Product Change Notification / SYST-09XAWH858

ERRATA - dsPIC33EPXXXGP50X, dsPIC33EPXXXMC20X/50X AND PIC24EPXXXGP/MC20X Errata
Document Revision

dsPIC33EPXXXGP50X, dsPIC33EPXXXMC20X/50X and PIC24EPXXXGP/MC20X Family Silicon Errata and Data Sheet Clarification

FIGURE 1: TIMING DIAGRAMS FOR CENTER-ALIGNED AND EDGE-ALIGNED MODES

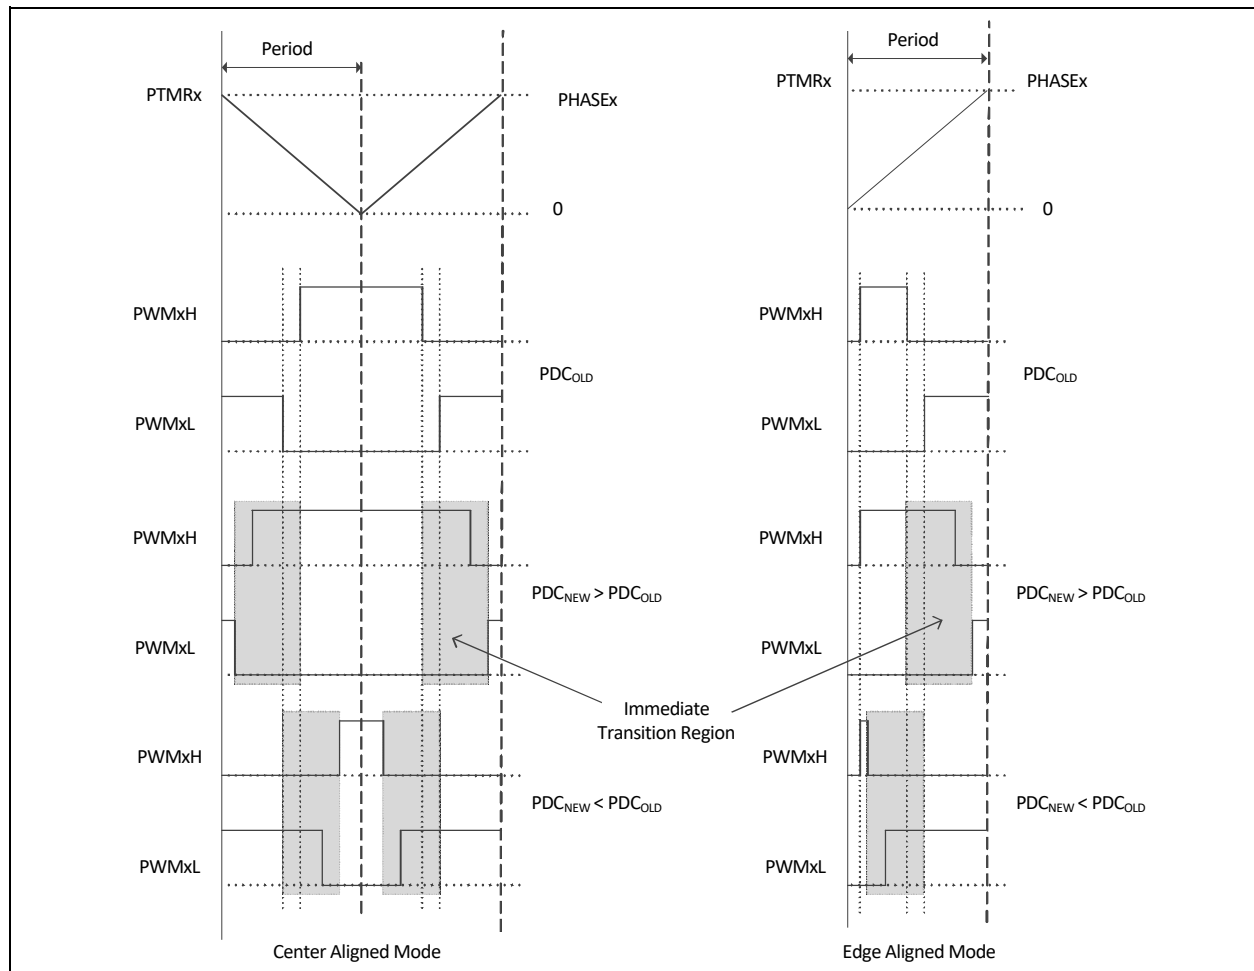
time base, will determine if the PWMxH and PWMxL outputs make an immediate transition. PWMxH and PWMxL outputs make an immediate transition if the Duty Cycle register is written with a new value, PDC_{NEW}, at a point of time when the PWM time base is counting a value that is in between PDC_{NEW} and PDC_{OLD}. Additionally, writing to the Duty Cycle register, close to the instant of time where dead time is being applied, may result in a reduced dead time effective on the PWMxH and PWMxL transition edges.

In Figure 1, if the duty cycle write occurred in the shaded box, then PWMxH and PWMxL will make an immediate transition without dead time.

None.

FIGURE 2: PWM TIMING DIAGRAM

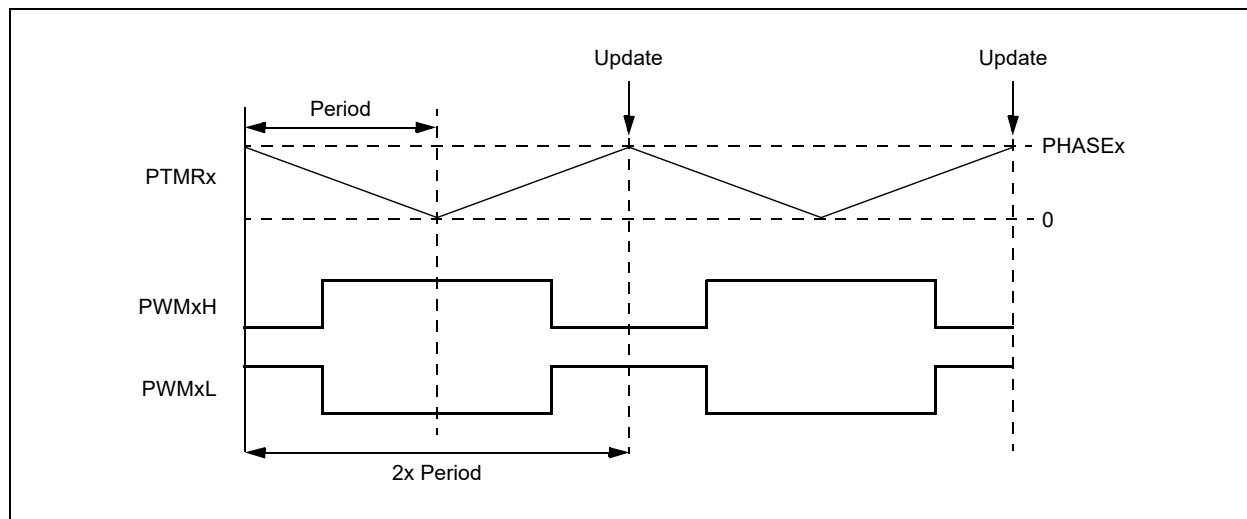
In Center-Aligned mode, updates to active MDC/PDC_x/ALTDTR_x/PHASE_x registers occur only once every two PWM periods; that is, when the PWM timer matches the PHASE_x register. In other words, the double update feature is not available. Figure 2 illustrates this relationship.

FIGURE 3: CORRECT AND INCORRECT POSITION COUNT CAPTURES

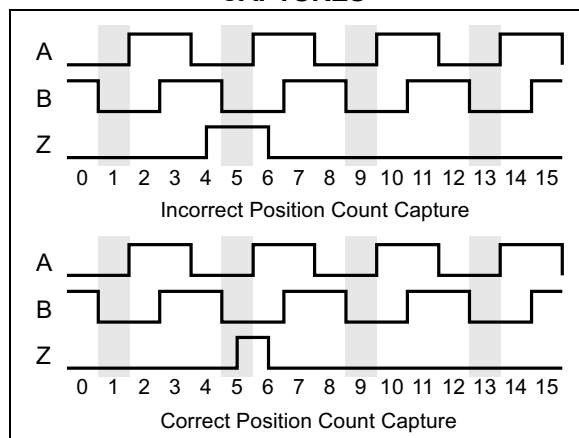
When index count position capture is being used (QE1IOC.QCAPEN = 1), the position count may be one more or one less than the correct value, depending on the direction of the count.

This is only observed when the leading edge of the index pulse occurs prior to the leading edge of the index match event. When the index pulse starts after the leading edge of the index match event, the position count is captured correctly.

Figure 3 shows how this occurs. In these cases, Encoder Signals A, B and (index) Z are shown, with the module being configured for index match when A and B are '0'. The effects of a correct and incorrect capture are shown side by side (shaded area indicates the index match event); the position count is shown along the bottom.

For encoder signals with timing that ensures the index pulse always starts prior to the start of the index match event (i.e., encoders with a non-gated index pulse), measure the direction of the encoder motion. If the encoder is counting up, add one to the captured position count; if the encoder is counting down, subtract one from the captured position count.

For encoder signals where the index pulse leading edge approximately coincides with the start of the index match event (i.e., encoders with a gated index pulse), a small delay can be added to the index pulse, for instance, by using a simple R-C filter.

FIGURE 4: PWM GENERATOR TIMING DIAGRAM

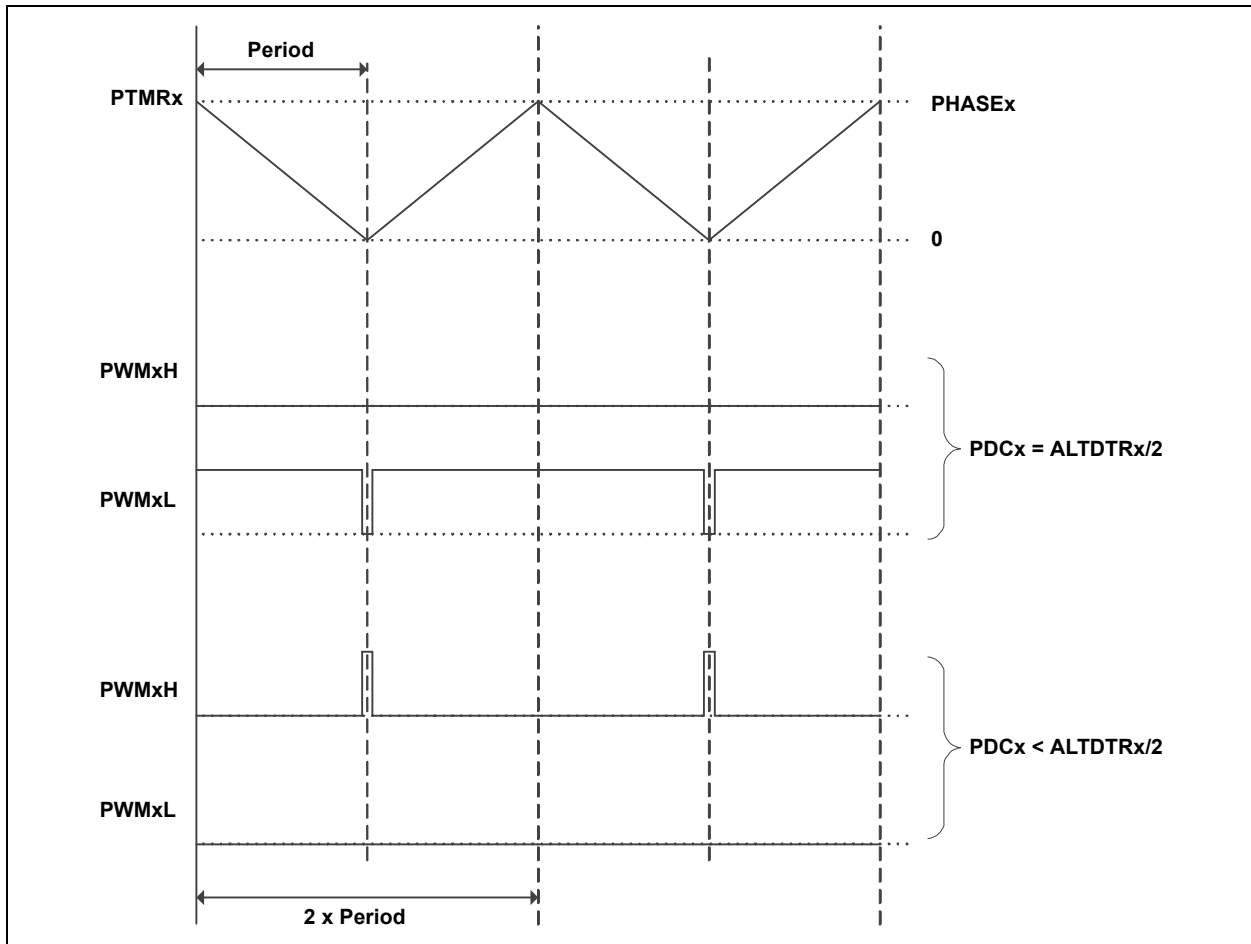
In Center-Aligned Complementary mode with Independent Time Base, if the value in the PDCx register is less than one-half the value in the ALTDTRx register, the PWM generator will force the PWMxL to low, and on the PWMxH, generate pulses of width less than twice the dead time, as shown in Figure 4.

FIGURE 5: ILLUSTRATION OF 1 T_{osc} GLITCH WHEN PWM OVERRIDE IS TURNED OFF

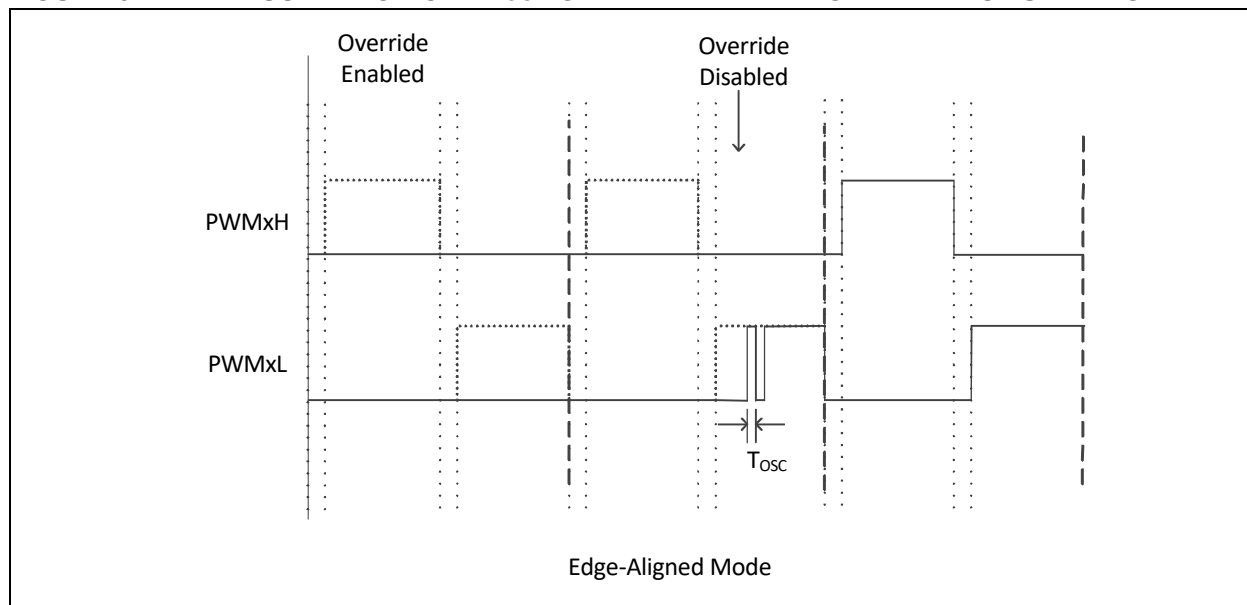
In Complementary mode after the PWMx module is enabled (PTEN = 1), if the PWM override is turned off, a 1 T_{osc} glitch will be present on the rising edge of either PWMxH or PWMxL, whichever occurs first, as shown in Figure 5. The glitch will be present on PWMxH/PWMxL every time the override state is changed from enabled to disabled. The width of this glitch is equal to 1 T_{osc} when PCLKDIV[2:0] = 000; increasing the PWM input clock prescaler setting will increase the width of the glitch accordingly.

FIGURE 6:

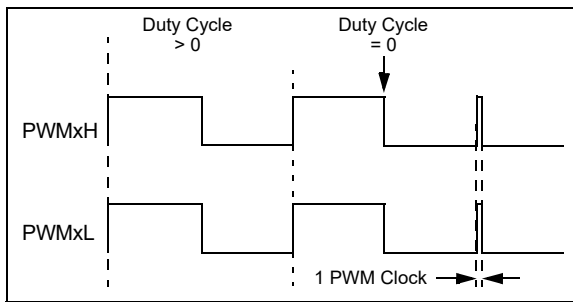
In certain output modes, the PWMx module produces a pulse glitch of one PWM clock in width (Figure 6). This has been observed only when all of the following are true:

- Either Redundant or Push-Pull Output mode is selected (IOCONx[11:10] = 10 or 01);
- Immediate Update is disabled (PWMCONx[0] = 0); and
- The value of the current Duty Cycle register (either the PDCx or MDC register, as determined by PWMCONx[8]) is updated to zero from any non-zero value.

The pulse glitch has been observed to occur at the beginning of the following PWM boundary period.

FIGURE 7:

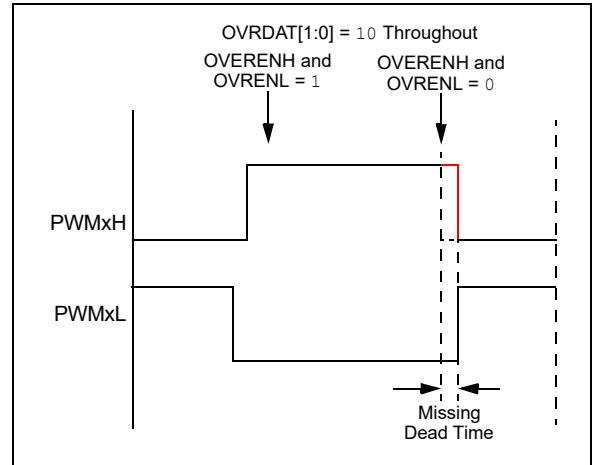
- Output override synchronization is configured to occur on the CPU clock boundary (IOCONx[0] = 0);
- Both PWMxH and PWMxL overrides are enabled prior to the event (OVRENH and OVRENL are both '1'), and
- Both overrides are disabled (OVRENH and OVRENL are both '0') at the instant the dead time should be asserted (Figure 7).

This has been observed in both Center-Aligned and Edge-Aligned modes.

FIGURE 8:

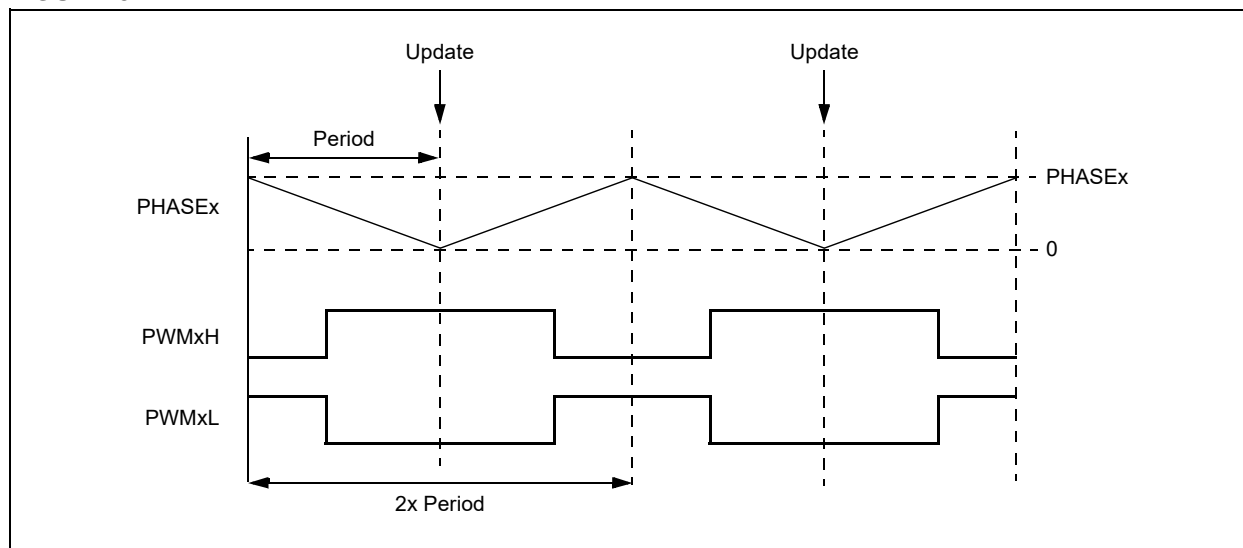
In Center-Aligned Complementary mode with Independent Time Base, updates to the PHASEx register take effect in the middle of a center-aligned PWM cycle, as shown in Figure 8. This occurs only when the Immediate Update feature is disabled (IUE = 0). If Immediate Update is enabled (IUE = 1), the PHASEx register updates will take effect immediately.

FIGURE 9: SIMPLIFIED BEHAVIOR

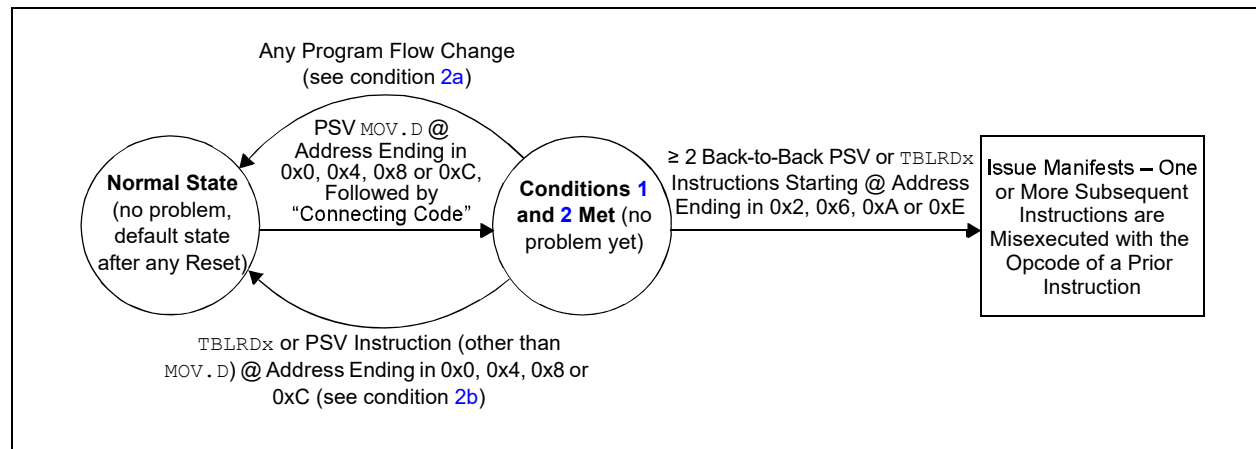
3.	≥ 2 back-to-back PSV or <code>TBLRDx</code> instructions are executed (following the code of condition 2), where the first of the back-to-back instructions is located at an address ending in 0x2, 0x6, 0xA or 0xE.

[Figure 9](#) provides an example of the effective behavior.

1. All instances of PSV `MOV.D` can be replaced with two PSV `MOV` instructions instead. Non-PSV `MOV.D` instructions acting on RAM/SFRs do not need to be modified; or
2. If not already present, a program flow change instruction (such as `BRA $+2`) can be inserted above back-to-back data Flash read sequences; or
3. Back-to-back data Flash read instruction sequences can be broken up by inserting a non-Flash read instruction (such as a `NOB`) in between the Flash read instructions; or
4. The alignment of the code can be shifted to avoid the required opcode location addresses.

C code built with MPLAB® XC16 Compiler, Version 1.32, or later, implements the work around by default. However, if the application uses Assembly language routines, these should be manually modified to implement the work around. Additionally, if precompiled libraries are used, these should be built with XC16 Version 1.32 or later. For additional information, please visit: www.microchip.com/erratum_psrds_psrds.
